SERVICE BULLETIN

DATE: 12 SEP 1977

REWORK OF PN 369A7120 LONGITUDINAL FRICTION GUIDE LINK, CYCLIC PITCH CONTROL INSTALLATION

Figure 1. Rework of 369A7120 longitudinal friction guide link to 369H7125 config.

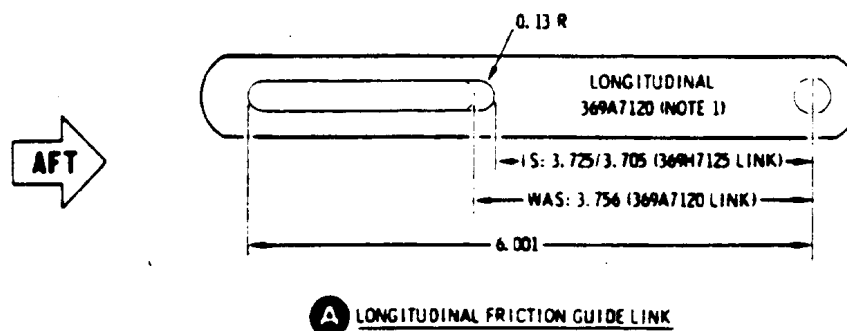
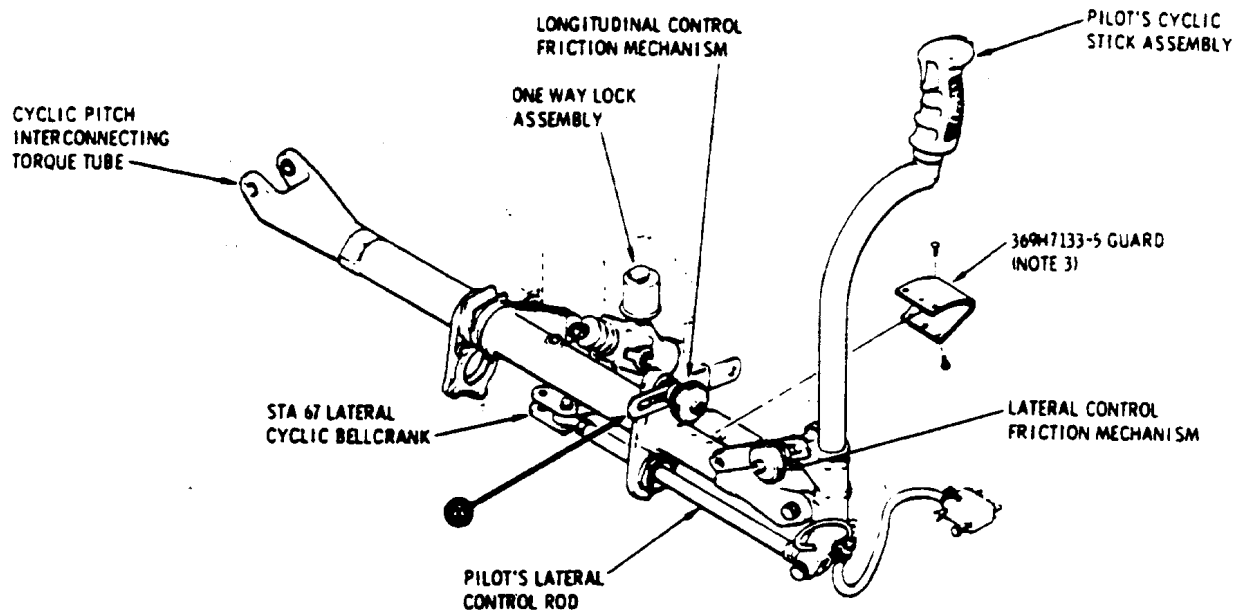
- (2). Using hand file or portable grinder, elongate aft end of slot in link, per dimensions shown in Figure 1.
- (3). Reidentify reworked link with new part number, 369H7125; use electric etching pen or impression stamp.
- (4). Reinstall link and cyclic friction mechanism.
- (5). Check cyclic stick operation through full travel of friction guide link slot.

NOTE: Early model helicopters may be equipped with 369H7133-5 guard riveted (6 places) to the interconnecting torque tube below the friction control mechanism (see figure 1). If guard is installed and interference between guard and seat structure is noted after rework of guide link, remove guard from torque tube.

1. AFTER REWORK, REIDENTIFY LINK PN 369H7125.
2. ALL DIMENSIONS IN INCHES.
3. REMOVE GUARD IF INTERFERENCE IS NOTED.
